SUBJECT: Forwards rev to 940314 response to NRC 931025 RAI re Topical
Rept WPPSS-FTS-131, "Applications Topical Rept for BWR
Design & Analysis."

Subject: **NUCLEAR PLANT NO. 2, OPERATING LICENSE NPF-21
REVISED RESPONSE TO REQUEST FOR ADDITIONAL INFORMATION
REGARDING TOPICAL REPORT WPPSS-FTS-131, "APPLICATIONS
TOPICAL REPORT FOR BWR DESIGN AND ANALYSIS" (TAC NOS.
M77048 AND M81723)**

**REVISED RESPONSE TO REQUEST FOR ADDITIONAL INFORMATION REGARDING
TOPICAL REPORT WPPSS-FTS-131**

**REVISED RESPONSE TO
REQUEST FOR ADDITIONAL INFORMATION
WASHINGTON PUBLIC POWER SUPPLY SYSTEM
TO REVISION 1 OF TOPICAL REPORT WPPSS-FTS-131**

**Figure 27-6 FWCF Results for 47% Power and
106% Flow, RPT Operable, Tech.
Spec. Scram Time**

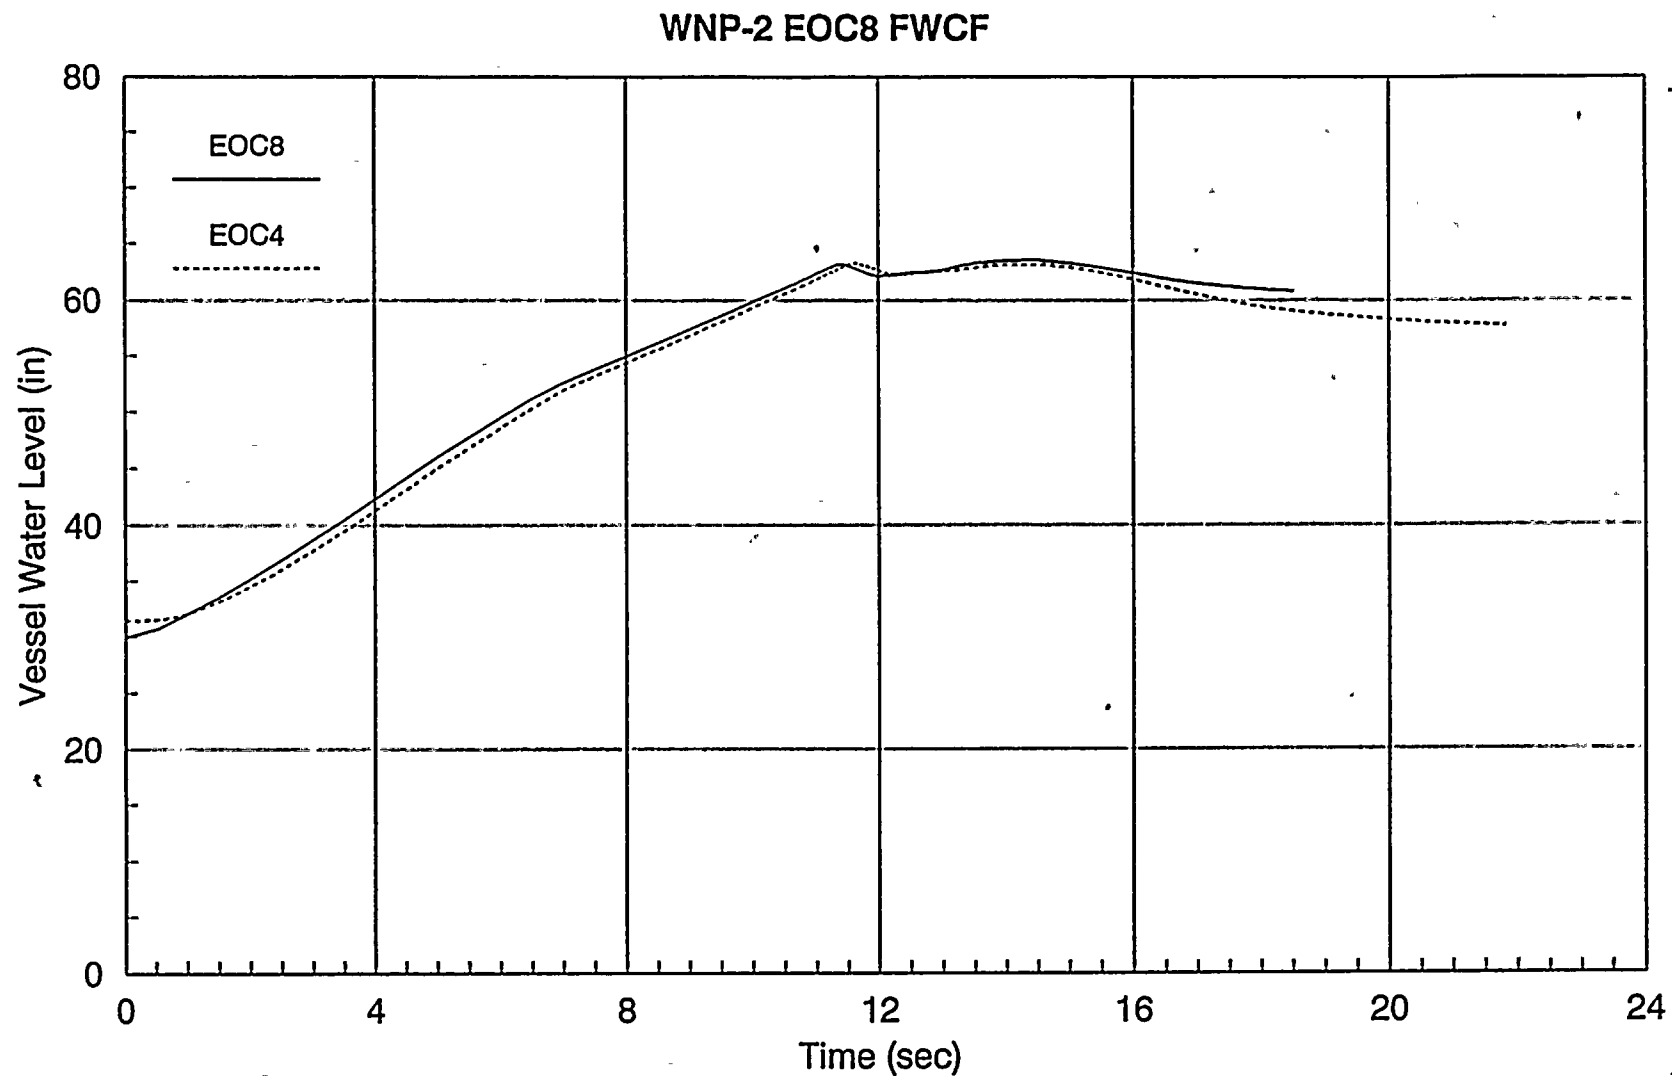
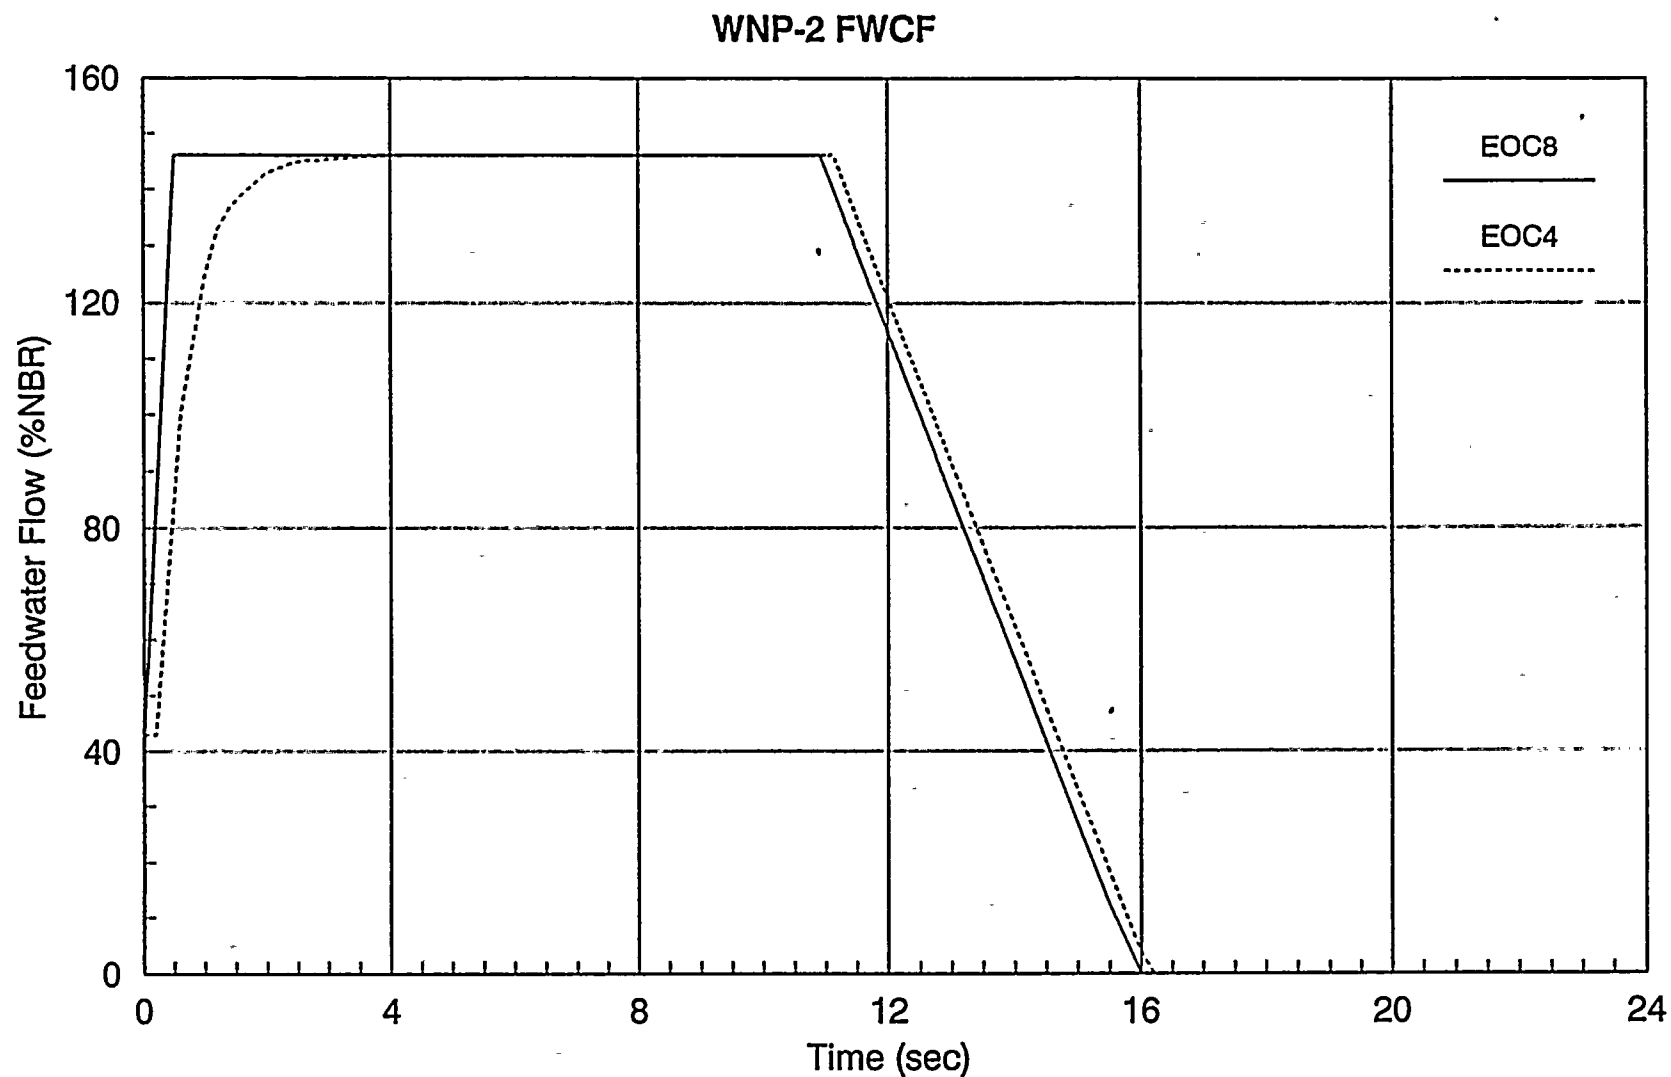
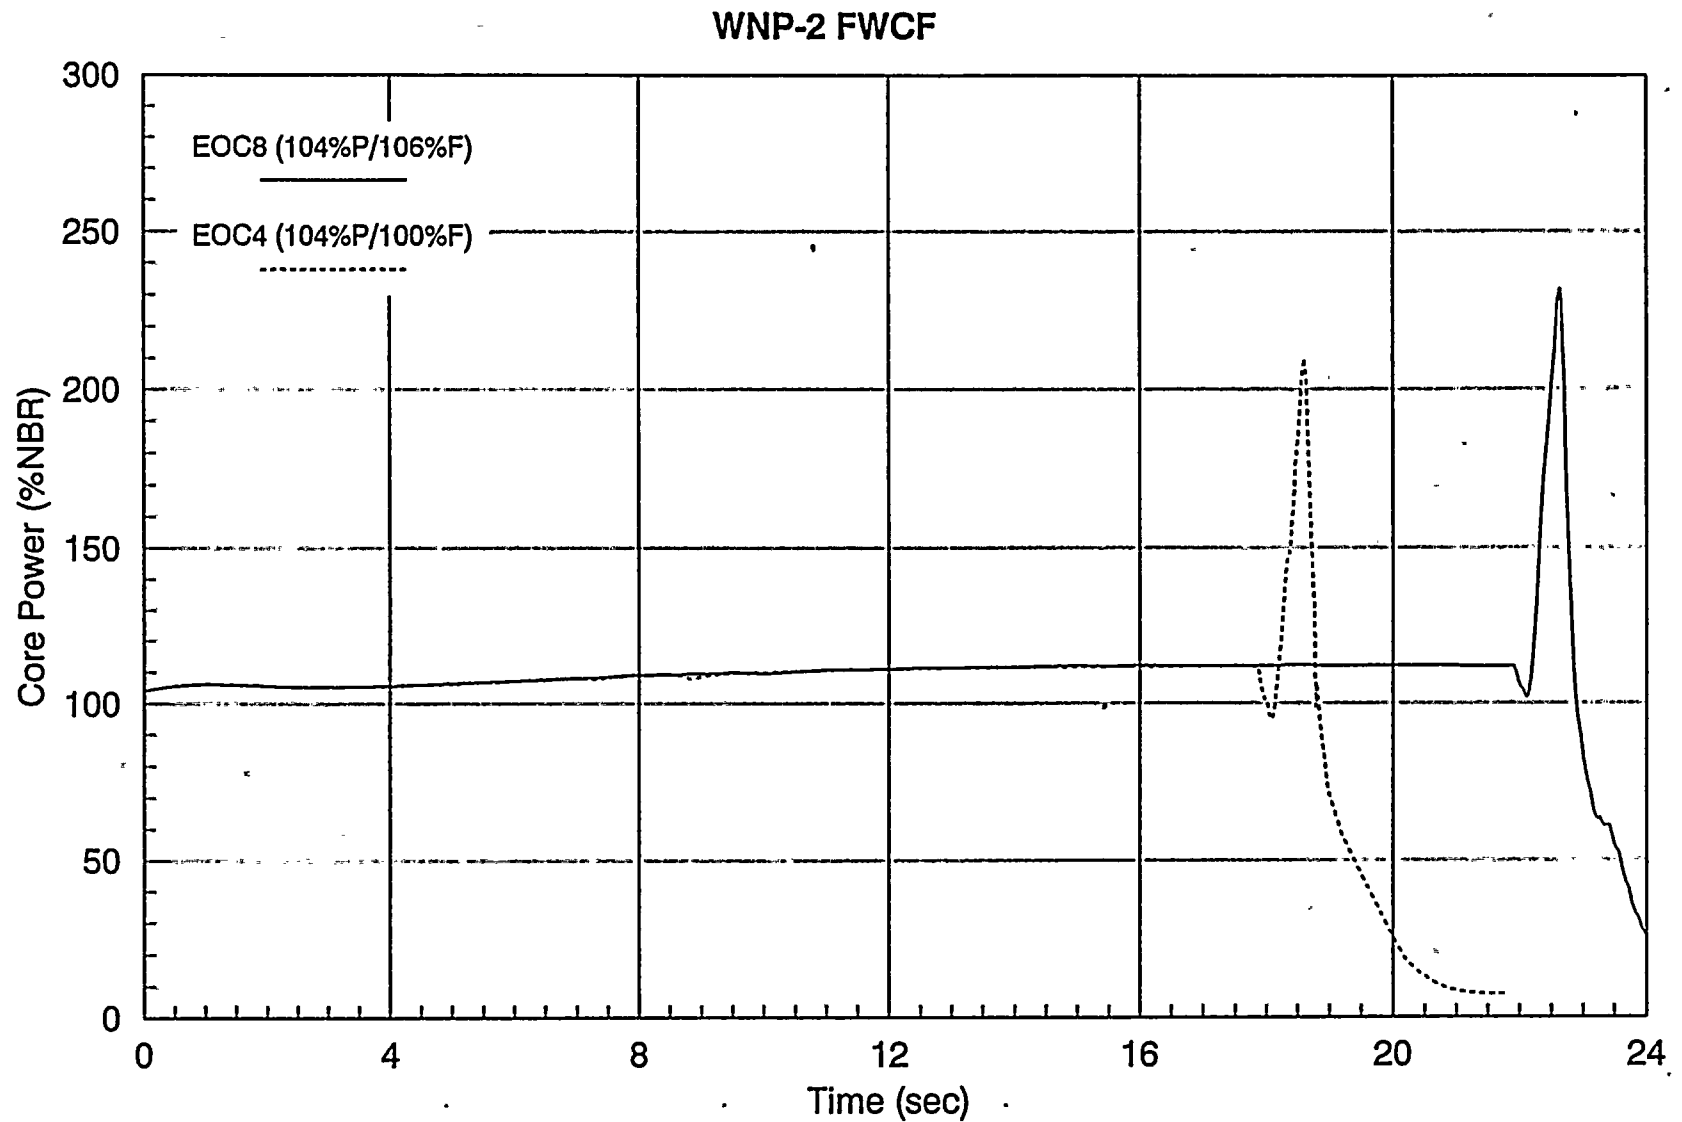
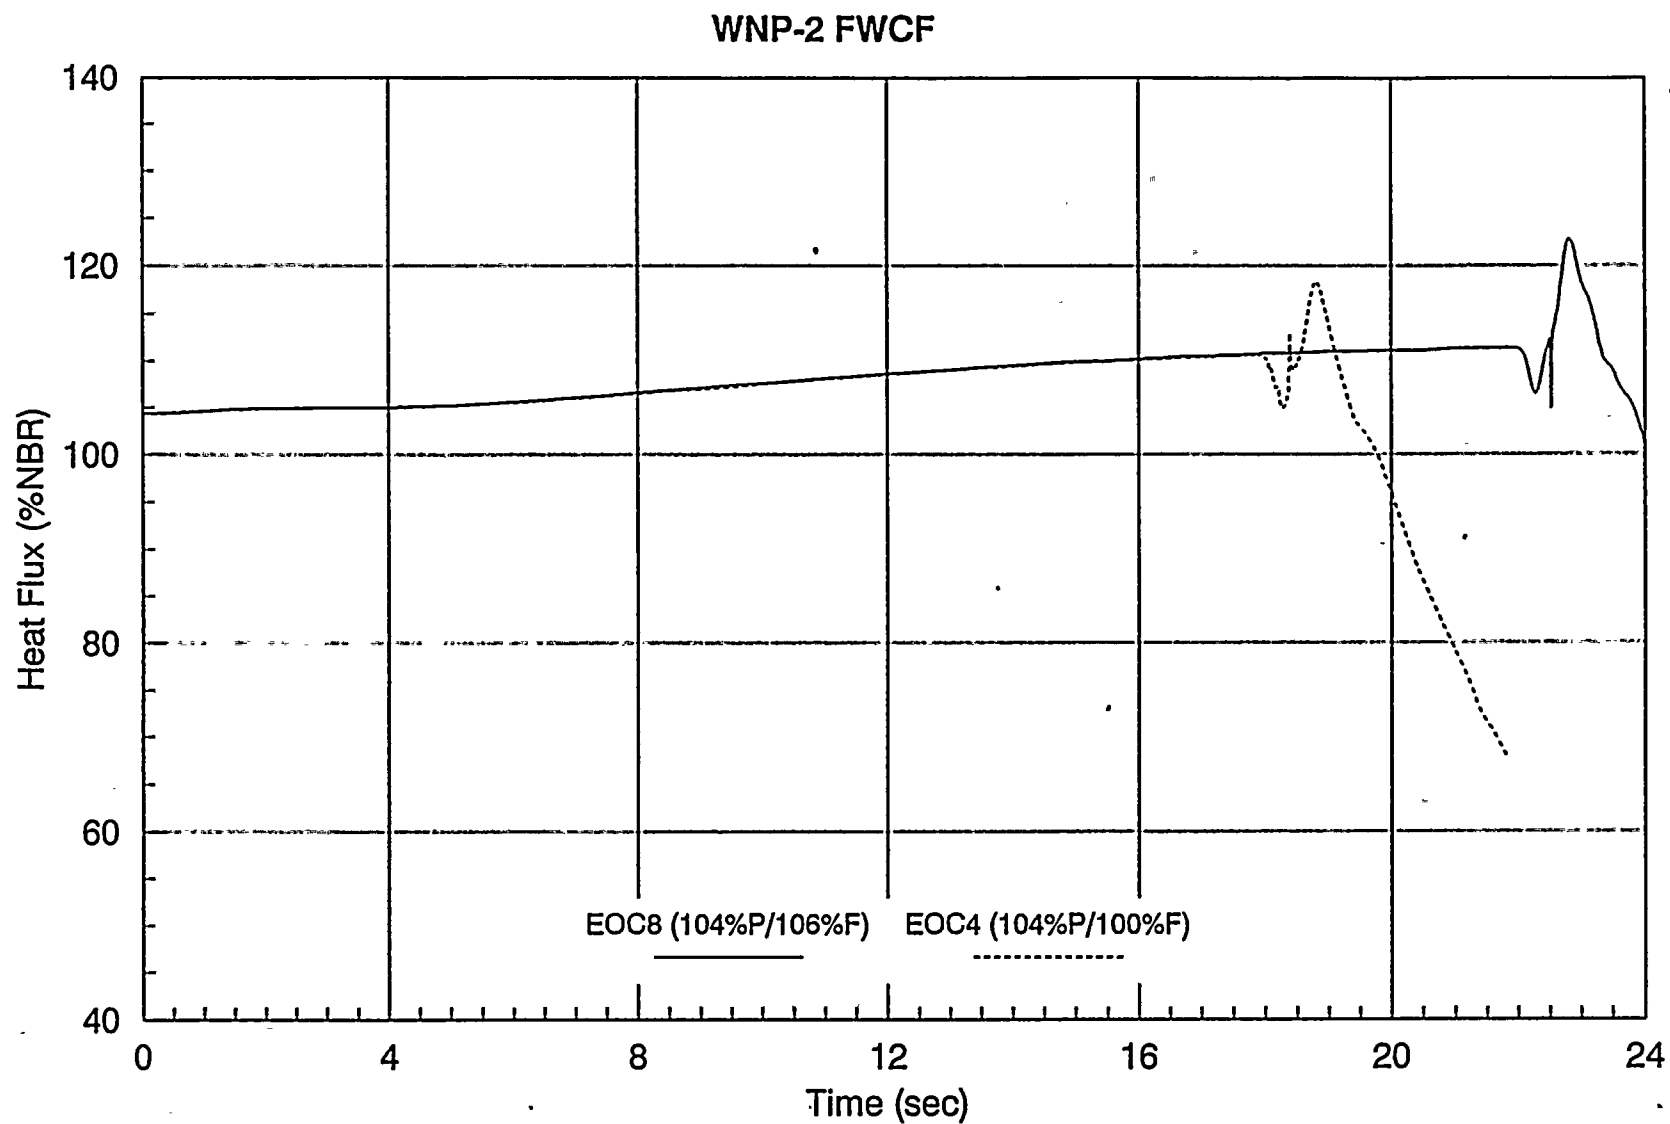
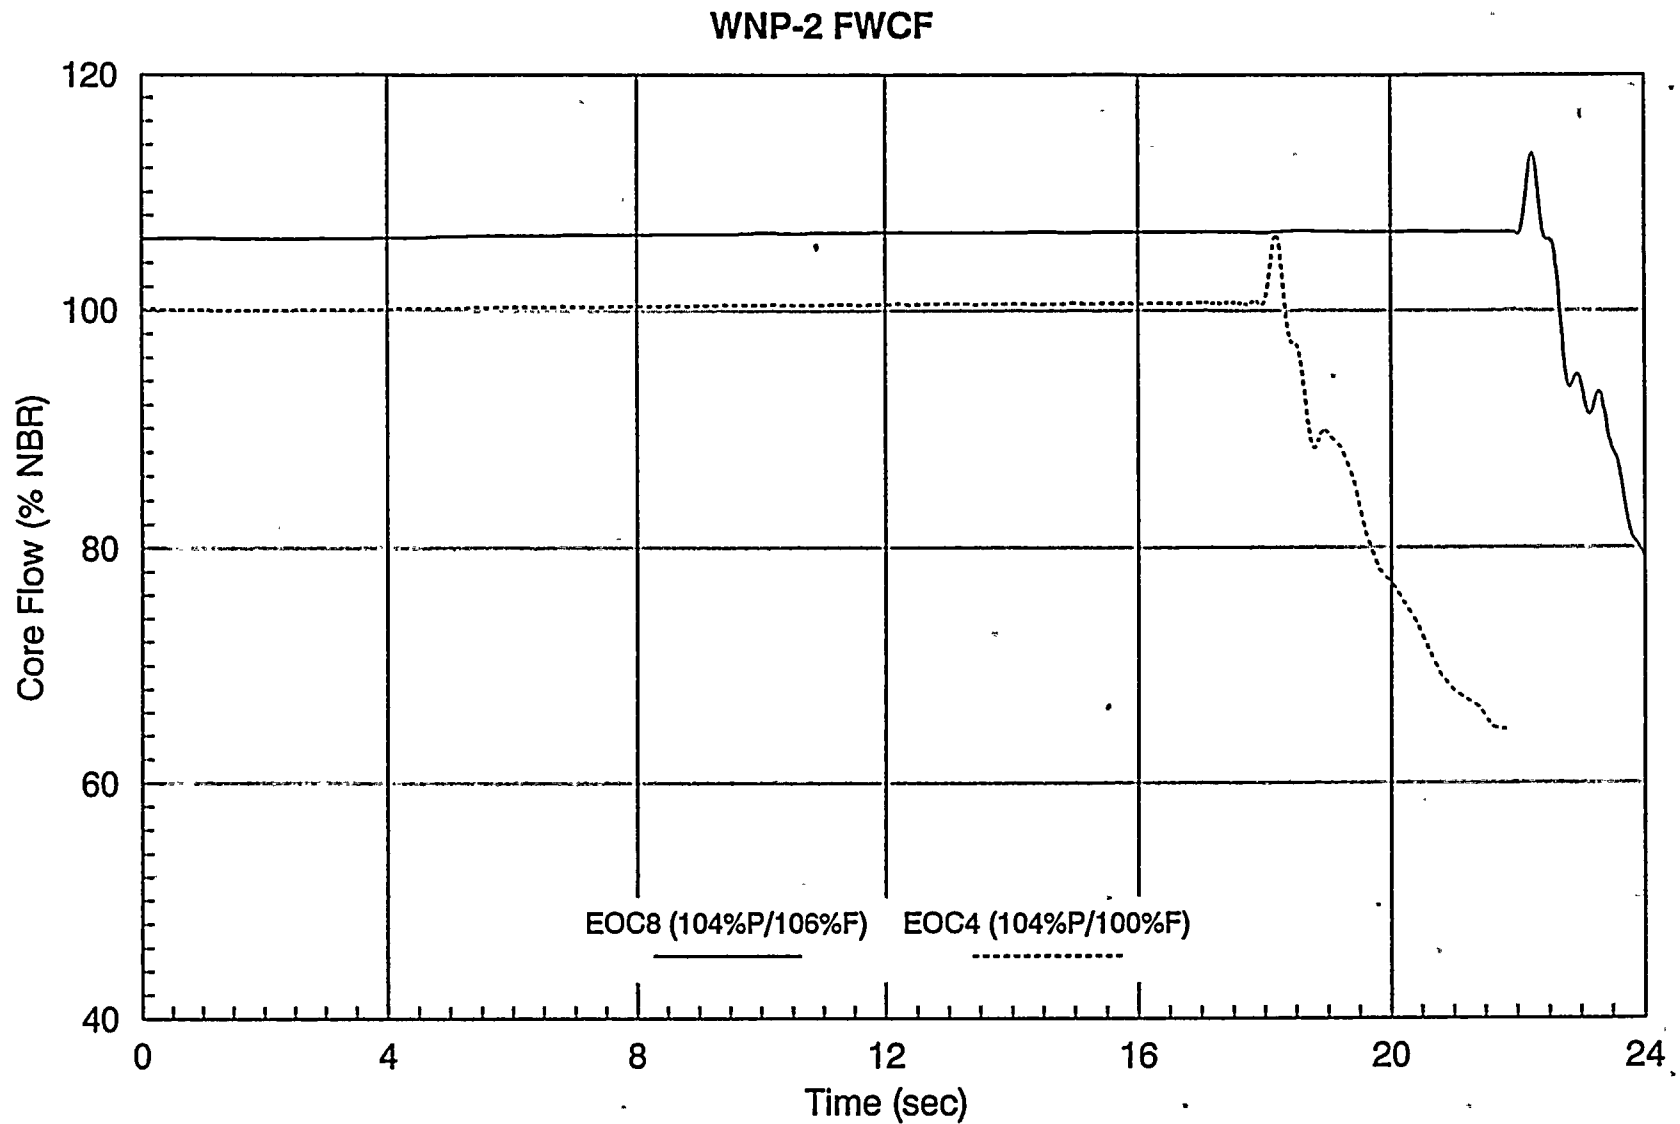
For the Feedwater Controller Failure event, there are dramatic differences between the results presented in Rev. 0 and Rev.1. Explain thoroughly these differences (shown on Tables 5.3.7-3 and 4 in Rev. 0 and Tables 5.3.7-4 and 5 in Rev. 1), and provide a complete set of plots comparing these two sets of analyses.

Improvements and corrections were made to the RETRAN-02 and VIPRE-01 models for WNP-2 after the Cycle 4 simulations were completed. The changes to the RETRAN-02 systems model included: vendor-based gap conductance methodology using the NRC approved RODEX2 code (see Applications Topical Report Revision 1); use of nominal recirculation pump inertia (see Response to Question 17); and mixed core modeling (see Response to Question 16). The initial water level at 104% power for the Cycle 8 analysis was a conservative value of low water level alarm L4 instead of the nominal level that was used in the Cycle 4 simulation. This causes a shift in turbine trip time as can be seen in Figures 27-8 through 27-14. The initial water level for the 47% power cases was set at L4 for both the Cycle 4 and Cycle 8 analyses. Also, the Cycle 4 analysis at 104% power used 100% core flow while the Cycle 8 analysis used 106% core flow.

The changes to the VIPRE-01 hot channel model are the use of vendor-based gap conductance and correction to the heated length calculation for the CPR correlation.
